DART SERVICE INSTRUCTION

TO AMEND INSTALLATION INSTRUCTIONS D412-673 REV. A

DSI-9374-011 Electric Step Bushing Kit was created to prevent possible wear of the D205-634-011 Skidtube Kit and/or loosening of the ALS7 inserts (provided in the D412-673-011 Electric Step Kit) during normal operation of the BHT 212-706-105-003 Electric Step. The DSI kit replaces the existing ALS7 inserts and hardware with qty(4) D3620-1 Bushings and associated hardware.

| DE APPR. |  | ELECTRIC STEP BUSHING KIT | NTS |

FIGURE 1 - TYPICAL BHT ELECTRIC STEP INSTALLATION
(REFER TO STEPS 1 AND 2 ON PG 1)

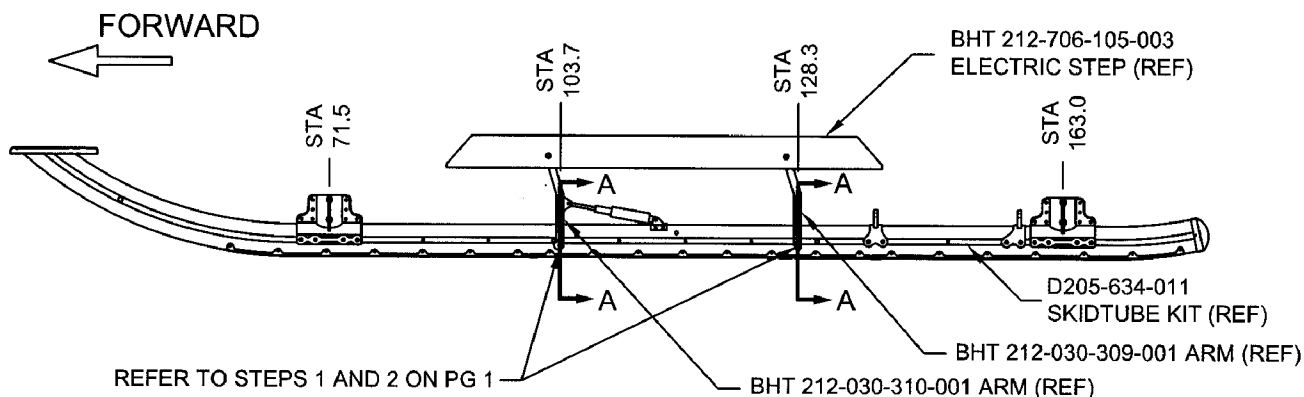
- 1) Disconnect the BHT 212-075-418-001 and/or BHT 212-075-418-003 Actuators from the Dart D205-634-011 Skidtube Kit per the Aircraft Maintenance Manual. Remove and discard the qty(4) BHT 212-030-119-001 bolts that fasten then BHT 212-030-309-001 and BHT 212-030-310-001 Arms to the skidtube as shown in **Figure 1** and temporarily move the electric step away from the skidtube.

- 2) Drill out the qty(4) ALS7-428-165 inserts installed in the skidtube at the two locations shown in **Figure 1**. Drill a $\varnothing 0.406$ " pilot hole through the insert holes and the web in the centre of the skidtube. Enlarge the holes to $\varnothing 0.438^{+0.006}_{-0.000}$ ". Deburr and touch up the holes per ICA-D205-634.

SECTION A-A
(REFER TO STEPS 3 AND 4 ON PG 1)

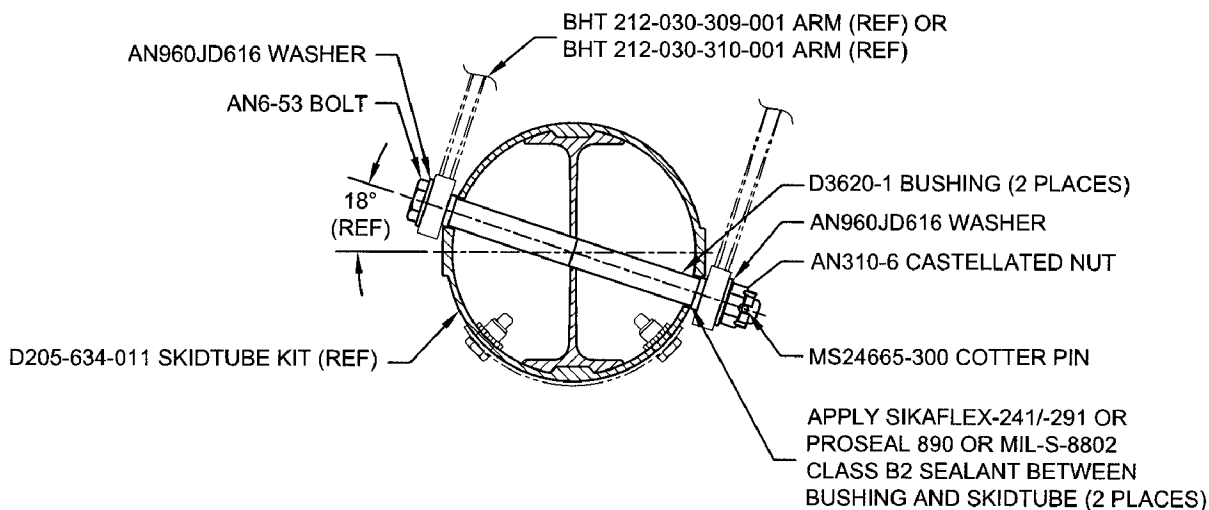
- 3) Install the D3620-1 Bushings into each hole (4 places) with Sikaflex-241/-291 or Proseal 890 or MIL-S-8802 Class B2 sealant as shown in **Section A-A**.

- 4) Re-install the electric step by connecting the BHT 212-030-309-001 and BHT 212-030-310-001 Arms as shown in **Section A-A**. Ensure all nuts are installed on the inboard side of the skidtube. Re-attach the BHT 212-075-418-001 and/or BHT 212-075-418-003 Actuators to the skidtube per the Aircraft Maintenance Manual.
